Docket Number:	00-AFC-14C
Project Title:	El Segundo Power Redevelopment Project Compliance
TN #:	200666
Document Title:	Applicant's Supplemental Responses to Certain Data Requests in Set One (17, 19, 23, 34, 36, 38, 40 and 56).
Description:	Disc of modeling data also received. Needs special program to view. If need to see contact the Dockets Office.
Filer:	Tiffani Winter
Organization:	Locke Lord, LLP
Submitter Role:	Applicant's Representative
Submission Date:	9/30/2013 5:04:33 PM
Docketed Date:	9/23/2013

Re El Segundo Energy Center Petition to Amend (00-AFC-014C)
Applicant’s Supplemental Responses to Certain Data Requests in Set One
(Nos 17, 19, 23, 34, 36, 38, 40 and 56)

**Data Responses, Set 1a
(Supplemental Response to Data Requests
17, 19, 23, 34, 36, 38, 40, 56)**

FIGURE DR23 1
Construction/Commissioning/Operation Impacts—NO₂

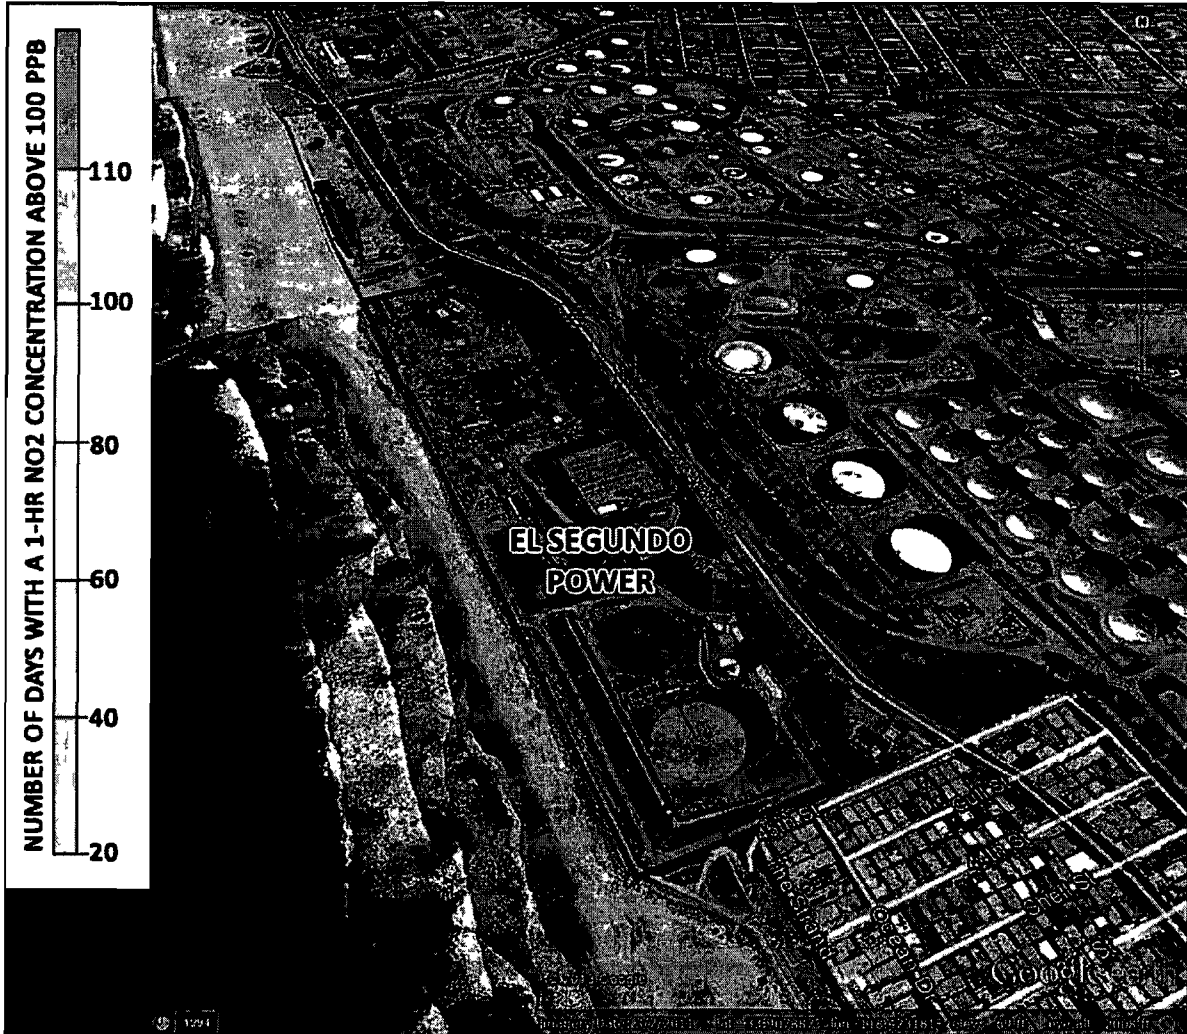
- 23 Please provide a more refined analysis that identifies the spatial extent and number of exceedances of the federal 1-hour NO₂ standard and 24-hour PM_{2.5} standard, including construction, commissioning and operations to evaluate the project's impact relative to these standards

Results of this evaluation are summarized in Tables DR23-2 and DR23-3. Figure DR23-1 shows the number of receptors where the model predicts NO₂ concentrations above the value of the standard, and the number of days at each receptor that such concentrations occur during the 3 year period described in the previous paragraph. Figure DR23-1 and Table DR23-2 show that concentrations above the 1-hour NO₂ NAAQS are not predicted more than 60 meters from the facility boundary.
